**Electromagnetic compatibility (EMC) –
Part 4-4: Testing and measurement techniques –
Electrical fast transient/burst immunity test**

CORRIGENDUM 2

Figure 14 – Verification of the waveform at the common mode output of the coupling/decoupling network

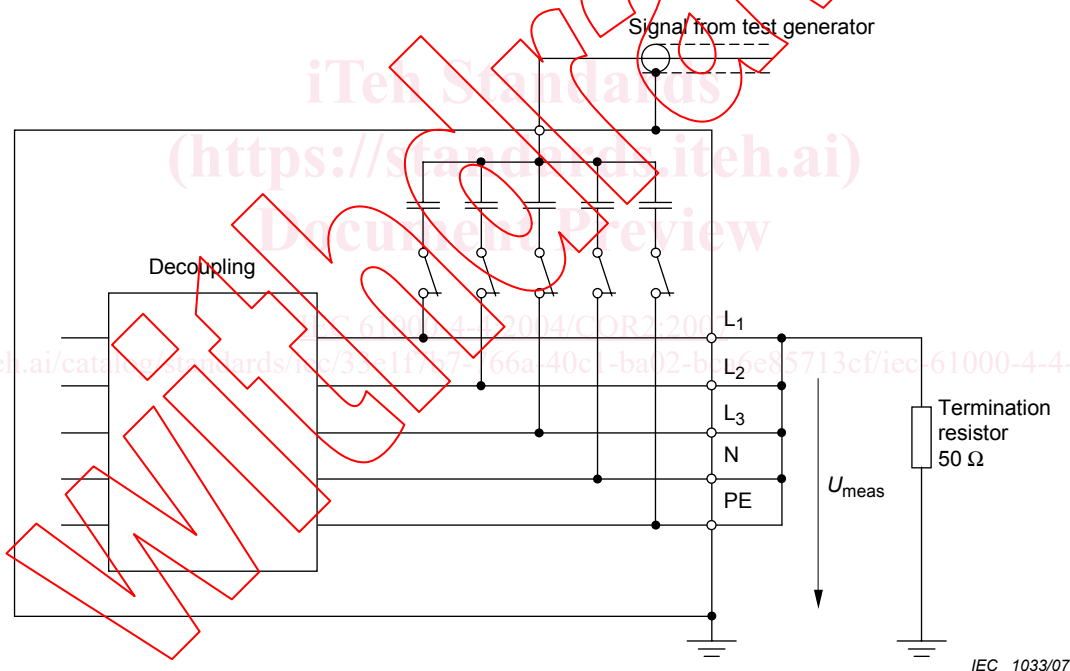
Replace the second paragraph by the following:

The waveform shall be verified at the common mode output of the coupling/decoupling network with all outputs tied together and a single 50 Ω termination as shown in Figure 14. In addition to verification of the waveform at the common mode output of the coupling/decoupling network, it is recommended that each individual output be checked to ensure that all outputs are functional."
